Access Compliance Report

Public Rights-of-Way

(Curb Ramps)

Intersection ID: 32056	Main Street: AZALEA RIDGE RD	Cross Street: PROVIDENCE RD	Location: SW
ADA ID: 034F4FC3D187	Ramp Type: Perp	Initial Pass/Fail: Fail	Overall Compliance: No
Severity Score: 21.25			
Codes/Mitigation Info/Possible Solution		Field Measurements/Component Compliance

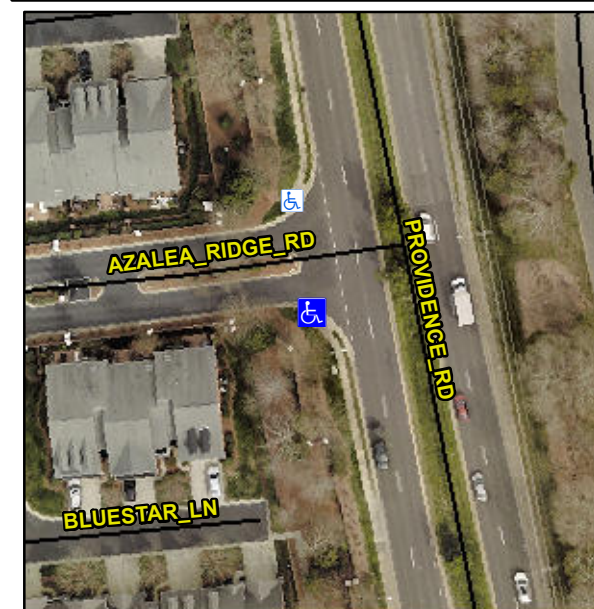
Not Found, R304.5.1, R304.5.3

Compliance	Description	Data	Compliance	Description	Data
N/A	Ramp Length (in)	76.0	Yes	Ramp Slope (%)	7.6
No	Ramp Width (in)	38.0	No	Ramp XSlope (%)	5.6
N/A	Flare Type LT	N/A	N/A	Flare Type RT	N/A
N/A	Flare Slope LT (%)	N/A	N/A	Flare Slope RT (%)	N/A
N/A	Flare Traversable LT?	N/A	N/A	Flare Traversable RT?	N/A
N/A	Landing Length (in)	N/A	N/A	DWS Provided?	N/A
N/A	Landing Width (in)	N/A	N/A	DWS Contrast?	N/A
N/A	Landing Slope (%)	N/A	N/A	DWS Length (in)	N/A
N/A	Landing X Slope (%)	N/A	N/A	DWS Full Width?	N/A
N/A	Landing Curb? (Y/N)	N/A	N/A	DWS Offset (in)	N/A
N/A	Shared Landing?	N/A			
N/A	Gutter Ponding?	N/A	N/A	Gutter Slope (%)	N/A
N/A	Gutter Lip Ht (in)	N/A	N/A	Gutter X Slope (%)	N/A
N/A	Painted X Walk1?	No	N/A	Painted X Walk2?	N/A
	X Walk 1 Direction	To N		X Walk 2 Direction	N/A
N/A	X Walk 1 Width (in)	N/A	N/A	X Walk 2 Width (in)	N/A
	X Walk 1 Slope (%)	3.5		X Walk 2 Slope (%)	N/A
	X Walk 1 X Slope (%)	5.5		X Walk 2 X Slope (%)	N/A

Remove & Replace Entire Ramp.
